Access Compliance Report Public Rights-of-Way (Curb Ramps)

Main Street: BRIOSO_ST Cross Street: RIBERA_RD Location: NE

ADA ID: RPRK211118125047 Ramp Type: Type 4 - Parallel Initial Pass/Fail: Fail Overall Compliance: No Severity Score: 2

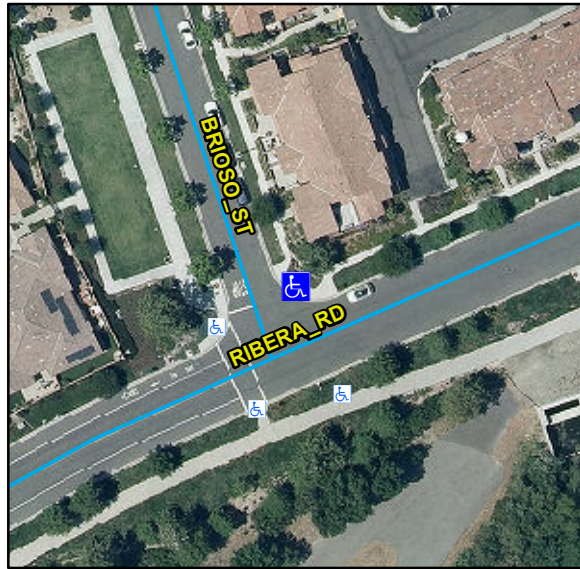
Compliance	Description	Data	Compliance	Description	Data
N/A	Ramp Length LT (in)	90	N/A	Ramp Length RT (in)	69
Yes	Ramp Width LT (in)	53	Yes	Ramp Width RT (in)	53
Yes	Ramp Run Slope LT (%)	5.6	Yes	Ramp Run Slope RT (%)	7.3
No	Ramp Cross Slope LT (%)	3.2	Yes	Ramp Cross Slope RT (%)	0.3
N/A	Landing Present	N/A	N/A	DWS Provided	N/A
N/A	Landing Length (in)	N/A	N/A	DWS Contrast	N/A
N/A	Landing Width (in)	N/A	N/A	DWS Length (in)	N/A
N/A	Landing Run Slope (%)	N/A	N/A	DWS Full Width	N/A
N/A	Landing Cross Slope (%)	N/A		DWS Offset Type	N/A
N/A	Landing Movement Obstructed?	N/A	N/A	DWS Offset Left (in)	N/A
	Landing Movement Type	N/A	N/A	DWS Offset Right (in)	N/A
N/A	Landing Shared	N/A			
N/A	Clear Space	Yes			
N/A	Clear Space To Crosswalk (in)	N/A			
N/A	Marked Crosswalk 1	No	N/A	Marked Crosswalk 2	No
	Crossing 1 Direction	W		Crossing 2 Direction	S
	Marked Crosswalk 1 Width (in)	N/A		Marked Crosswalk 2 Width (in)	N/A

Remove & Replace Curb Ramp With Two New Directional Ramps or Equivalent.

R304.5.3, STD 1115
